Appl. No. 09/745,702
Atty. Docket No. 8384
Amdt. dated January 30, 2004
Reply to Office Action of Oct. 30, 2003
Customer No. 27752

Amendments to the Drawings:

Fig. 1

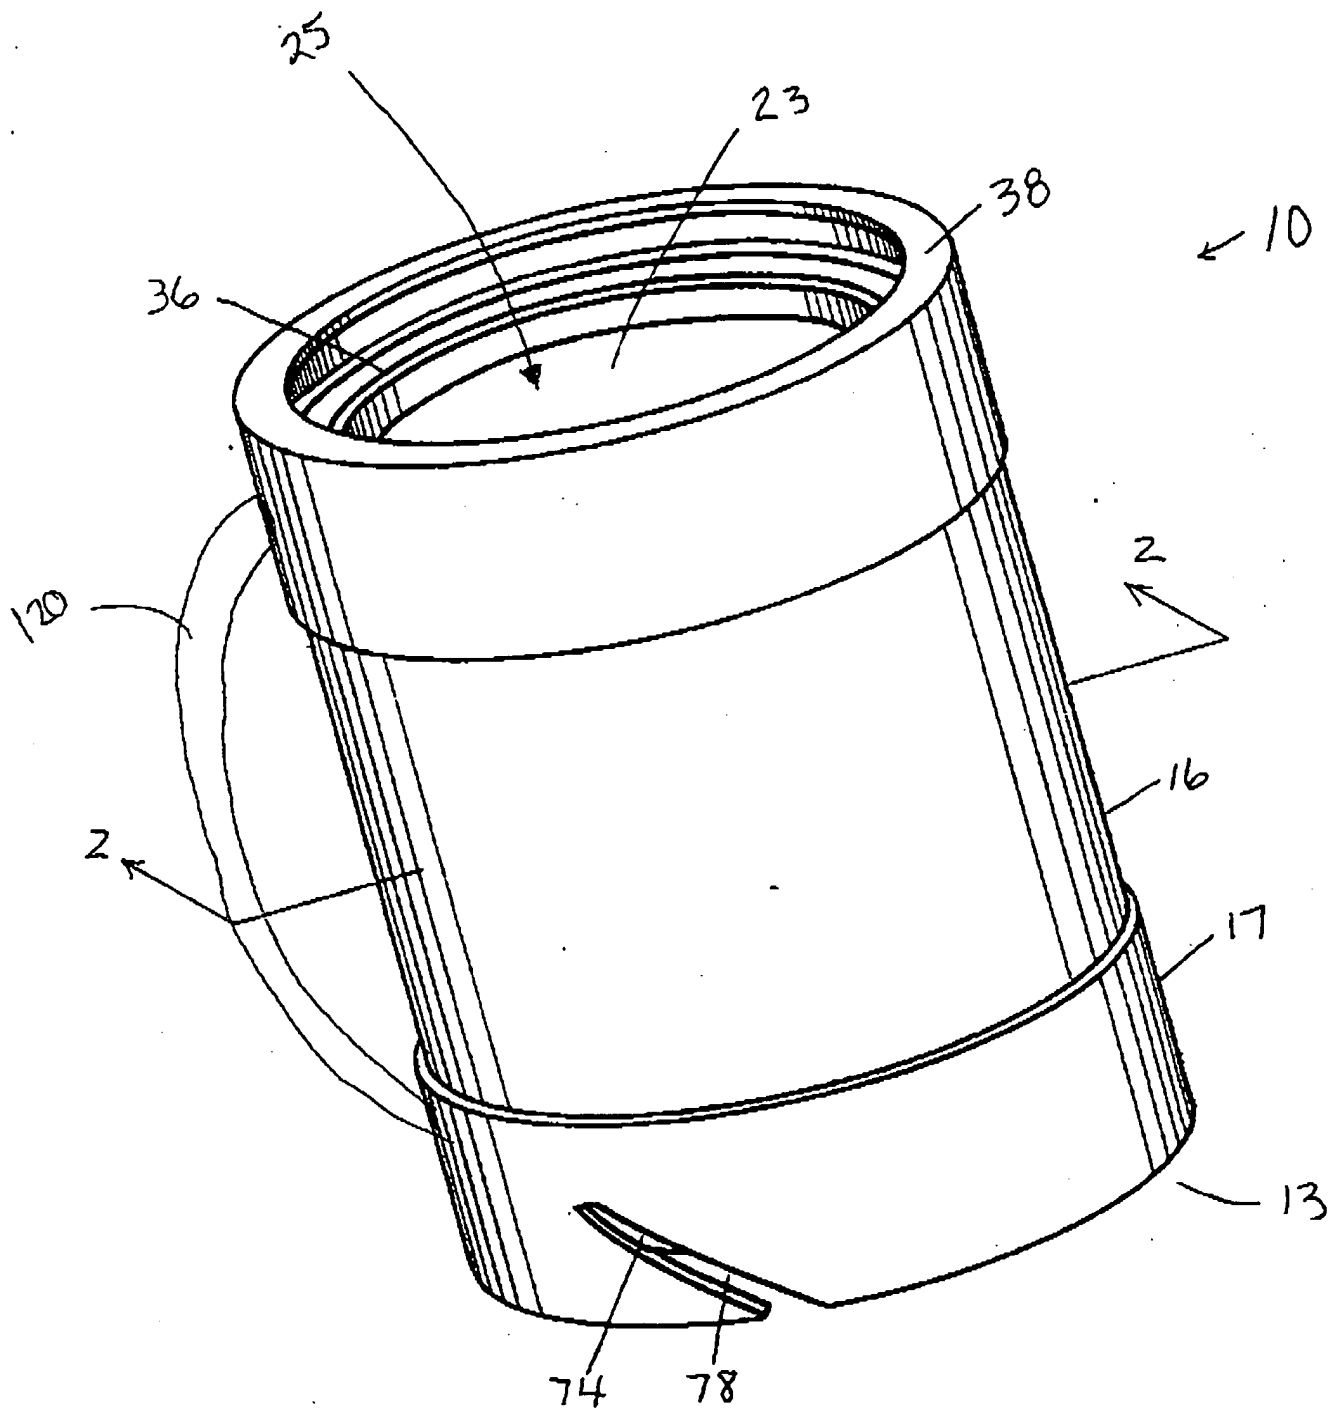
The Office Action has objected to the drawings under 37 C.F.R. § 1.83(a). The Office Action requests that the drawings show the "handle" that is claimed in claim 9, line 2. Similarly, the Office Action requests that the drawings show the "shape of the outlet opening and a portion of the passageway" being oval or elliptical in claim 10, lines 20-21.

The attached annotated sheets showing changes for Figures 1 and 3 are submitted herewith. Formal drawings will be submitted subsequent to this response.

handle 120

25 - passageway
